Revised Analyses of Decommissioning for the Reference Pressurized Water Reactor Power Station

Effects of Current Regulatory and Other Considerations on the
Financial Assurance Requirements of the Decommissioning Rule
and on Estimates of Occupational Radiation Exposure

Final Report

Figure D.2 Present value costs for SNF storage operations

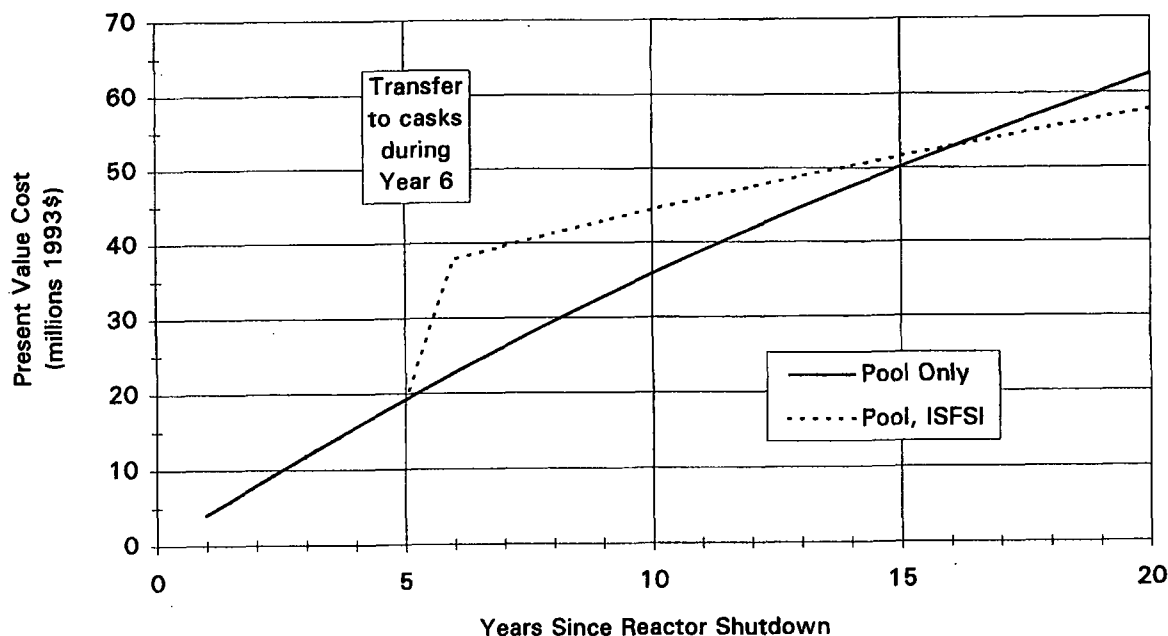
Comment: Figure D.2, which compares the present value cost of the pool option vs. the ISFSI option, does not present a valid comparison. First, the use of the 3 % discount rate distorts the comparison. Second, the assumptions favored the pool option more than the ISFSI option. Third, and most importantly, the comparison does not address the impact on the overall decommissioning cost and schedule.

Response: The revised Figure D.2 illustrates the cumulative present values of the costs for SNF storage, using either the pool-only approach or the pool + ISFSI approach. The net result of the analysis would tend to favor pool-only storage for the first 16 years. If the inventory remains greater than zero beyond 16 years, the ISFSI approach becomes more cost-effective. The estimated annual cost for safe storage operations during the pool storage period are about \$936 K in constant 1993 dollars. Thus, the D&D costs would increase by that amount for every year that the pool remained in service.

Figure E.1 Upper core assembly

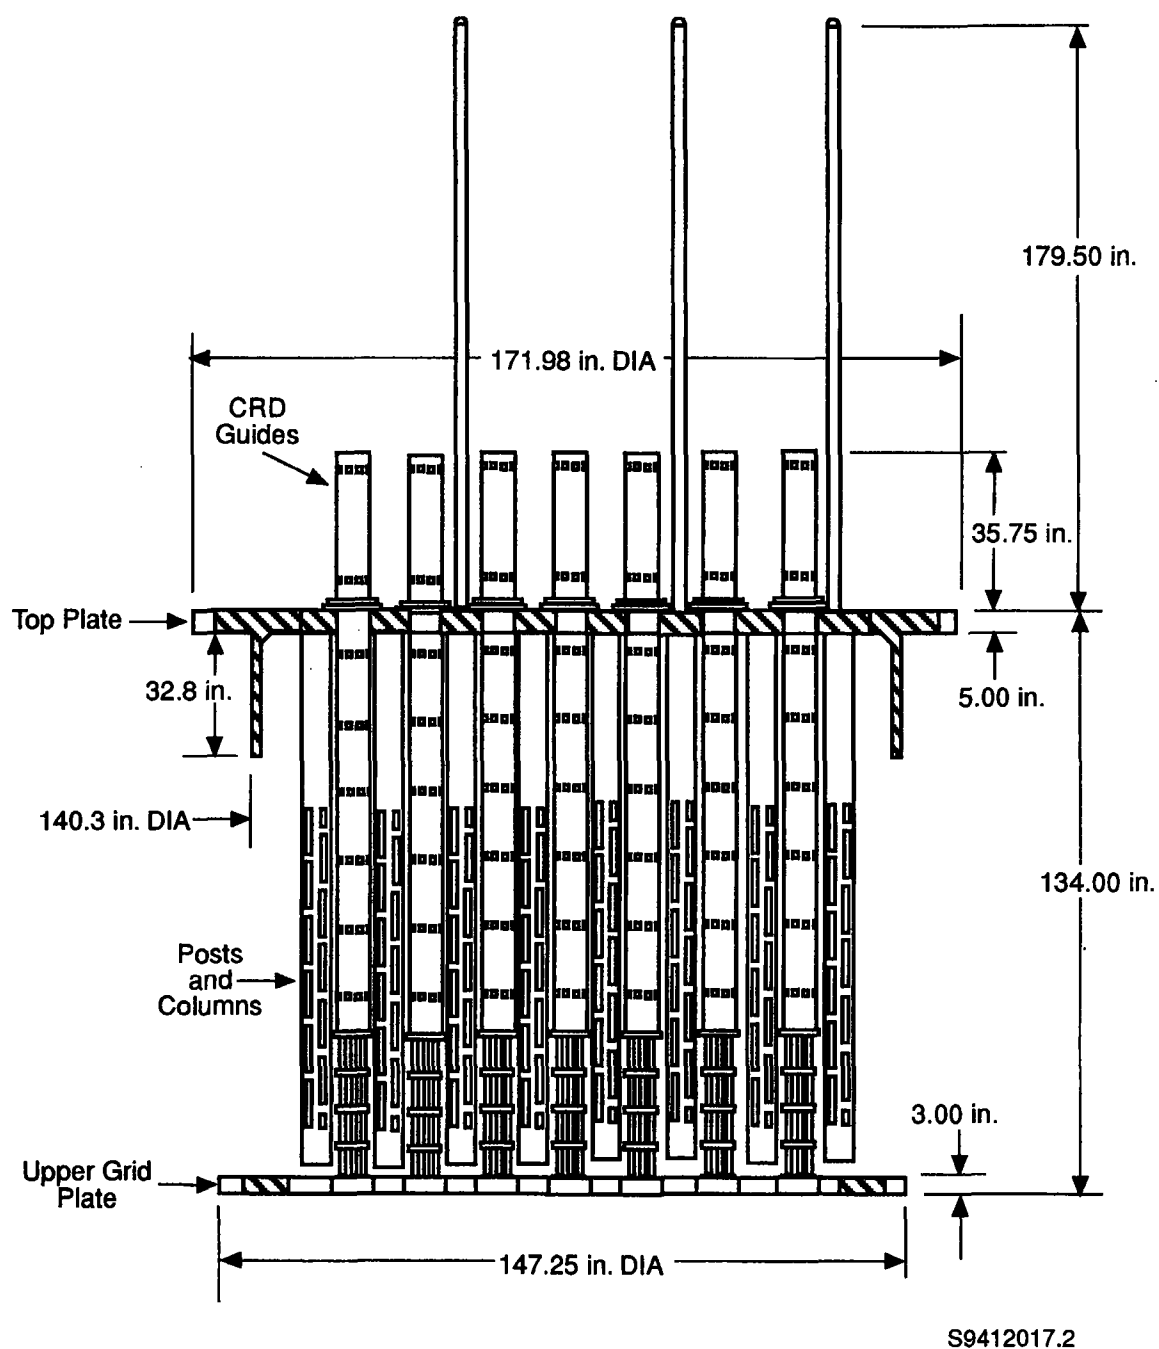
006-7 Comment: Section E describes the components of the reactor and internals. Figures E.1 and E.2 show many of these, but not all components are labeled and the names of those which are labeled do not always have the same names used in the text.
